Service Bulletin

S.B. No: 187

Title: INSPECTION FOR CLEARANCE BETWEEN RUDDER PEDAL AND MIXTURE/PROP. SPEED BRACKET. ALSO INCLUDES GENERAL RUDDER PEDAL CLEARANCES.

Applicability: T67M200 (Works No. 2264 & 2265 only) and T67M260

FIGURE 2

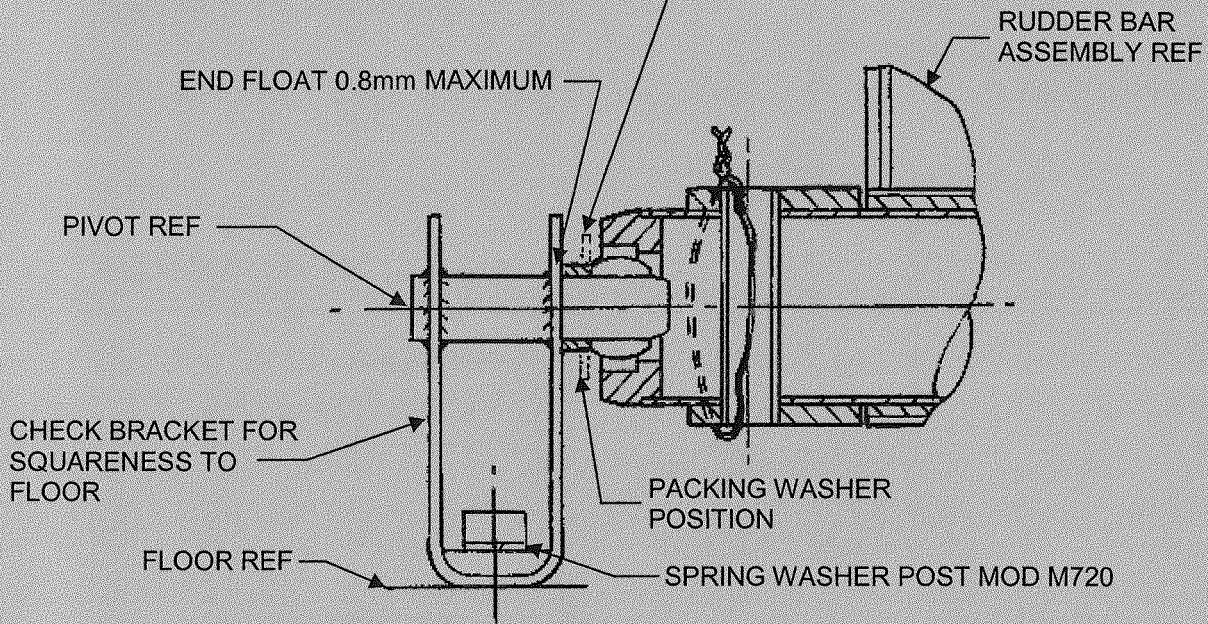
4. Check rudder pedal bar end float is no greater than 0.8mm. If it is greater than 0.8mm then rectify end float IAW paragraph 9. Refer Figure 2.
5. Check that the Rudder Pedal bar port outboard support bracket, ref. Figure 4, is square to floor and not "lozenged" and there is no deformation to its base. Check floor panel under area of bracket, inspect for cracking which could allow the bracket to lean. If necessary remove floor panel and check for signs of cracking in the floor around the anchor nuts on Pre Mod M919 aircraft or the anchor nut mounting plate Post Mod M919 aircraft, refer Figure 3. Any GRP damage will be shown as a white shadow on the GRP, with cracking felt as a rough edge. A light shining up through the floor will show a shadow.

9. Referring to Figure 2 ensure at each rudder bar pivot position that there is one spacer T67M-45-507 OR one off washer 126-23-748 and up to a maximum of two off washers 126-23-749, i.e. 3 washers maximum.

If end float greater than 0.8mm, then 1 off packing washer may be added at each pivot position as required, i.e. 126-23-105 washer or 126-23-748 washer or 126-23-749 washer.

If packing washers are required on the right hand rudder bar (T67M-45-259), then the packing washer, (or the thicker washer if a thick and thin washer are required) should be placed at the outboard pivot. When end float of 0.8mm maximum is achieved, ensure that the brake cylinders are not subject to undue side load. If in doubt, contact SACL.

SPACER T67M-45-507 OR 1 OFF WASHER 126-23-748 PLUS 1 OR 2 OFF 126-23-749 WASHERS MUST BE FITTED

FIGURE 4

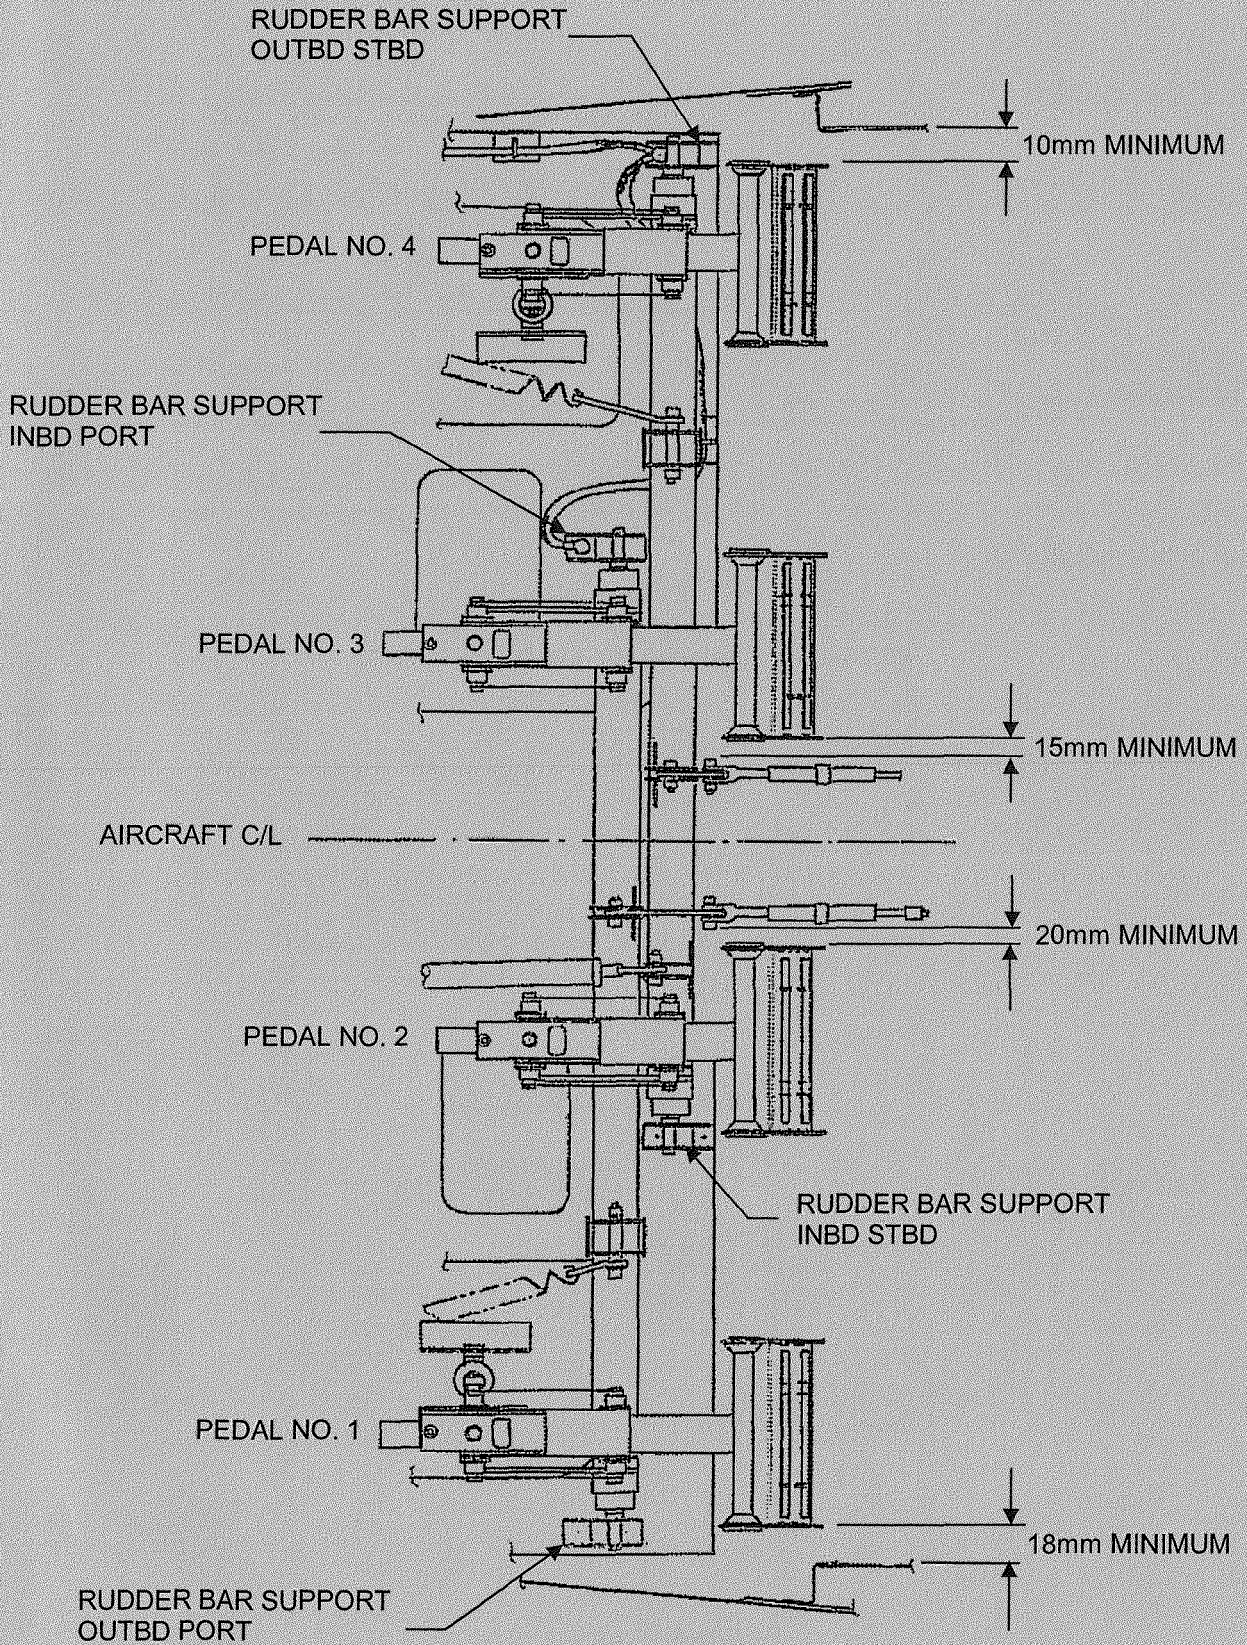
8. Check the remaining rudder bar support brackets, ref. Figure 4, are square to floor and not "lozenged" and there is no deformation to their bases. If any bracket is found to be suspect replace with new item. Inform SACL of any damaged bracket. Assemble item as per paragraph 7 and ensure end float is as stated in paragraph 9. Ensure bonding leads are correctly fitted, carry out bonding check refer relevant aircraft's Maintenance Manual.

13. Upon completion of rudder movement set-up ref. Paragraph 11 above, ensure minimum clearances of trim panel to pedal side plates and rudder cable to pedal side plates are met Refer Figure 4. Refer paragraph 9 for packing washers.

FIGURE 5

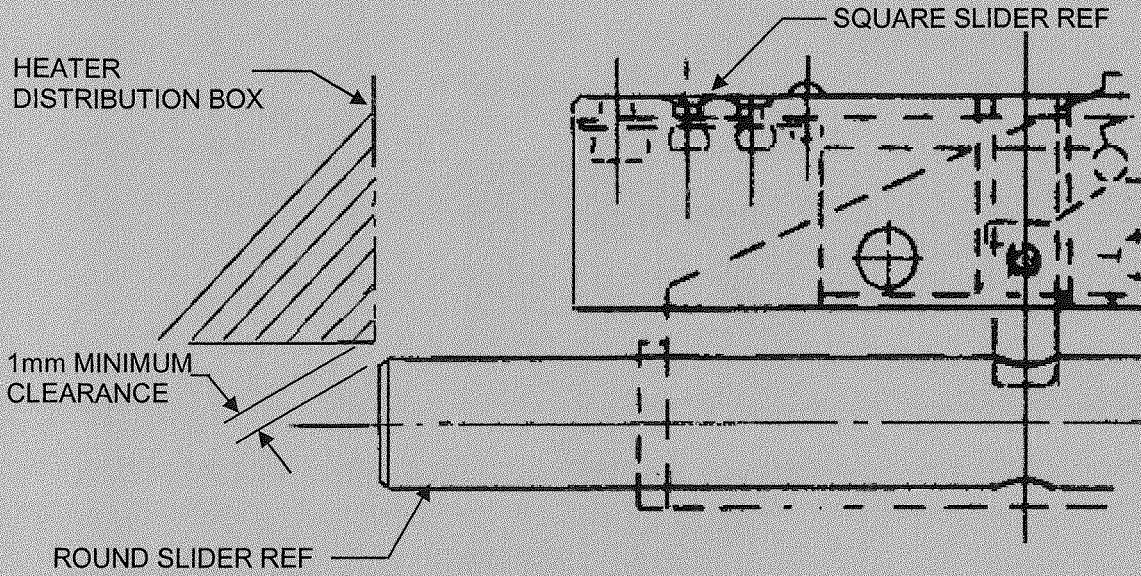
14. Ensure clearance of the no. 2 pedal slider to heater box clearance, is greater than 1mm, Figure 5 refers. Inform SACL if clearance is not achievable.

FIGURE 6

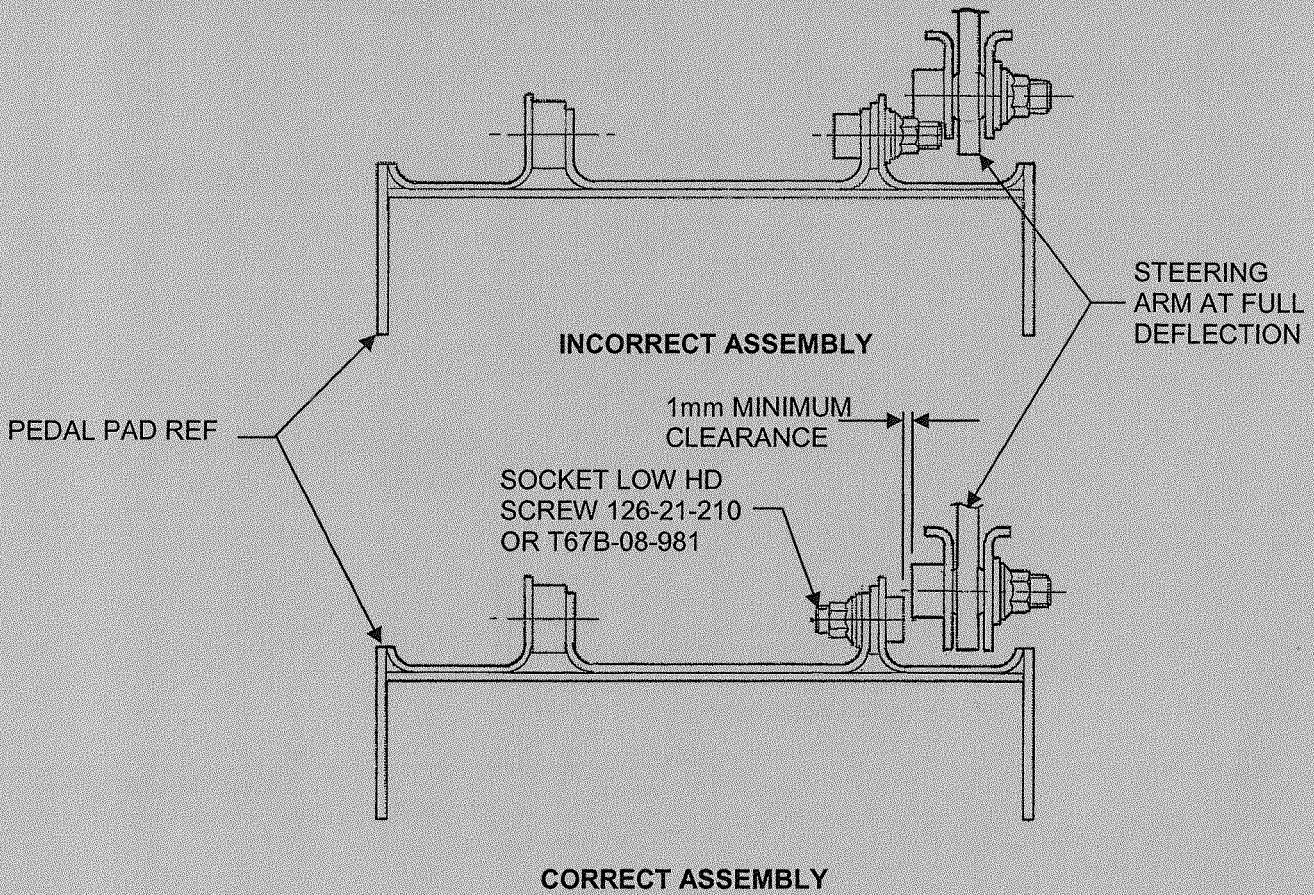
17. Ensure head orientation of rudder cable link low pan head bolt T67M-45-570 is outboard. T67M260 Maintenance Manual Figure 5-7 refers.
18. Ensure Pedal no 2 Pedal pad pivot bolt head height is less than 5mm and orientated, as shown in Figure 6. A minimum of 1mm clearance is required, if not, fit part no 126-21-210 or T67B-08-981, this invokes Mod M671 "Introduction of Low Head Rudder Pedal Pad Pivot Bolts – Pedal No. 2".

FIGURE 7

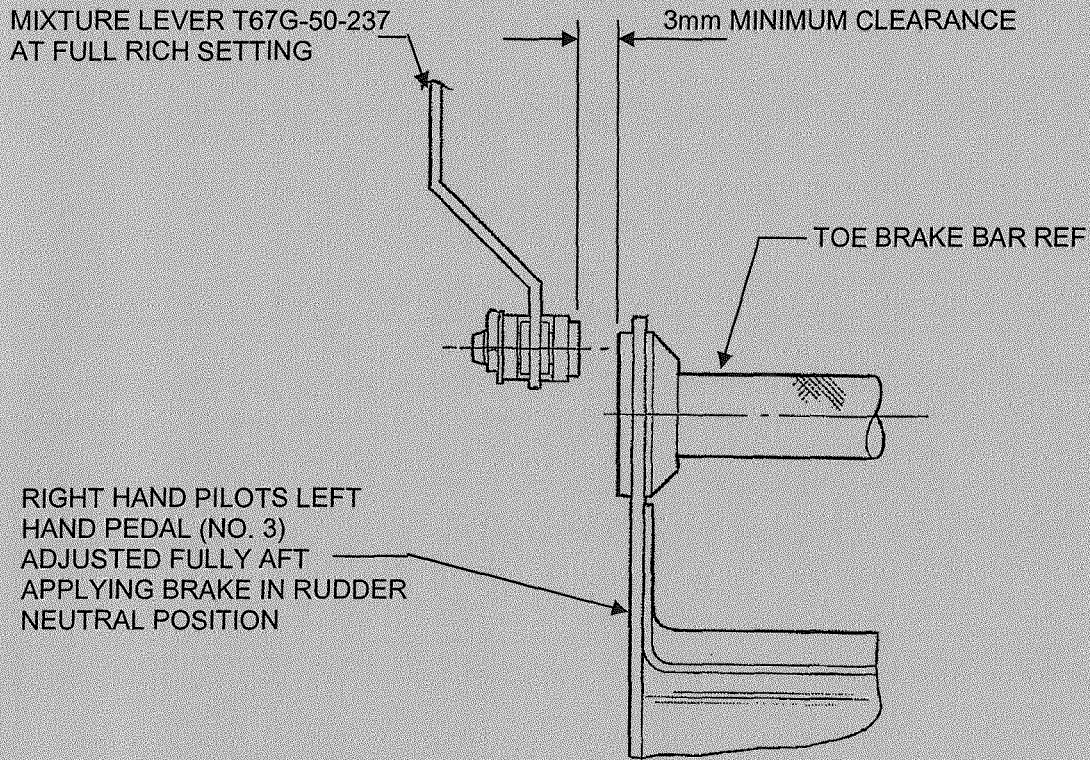
19. Ensure that the requirements of SB 99, "Inspection and Rectification of Rudder Pedal Sliders", has been achieved.
20. Ensure, that a minimum clearance of 3mm is achieved between Pedal No 3 and Mixture Lever operating arm, refer Figure 7. Refer paragraph 9 for packing washers.
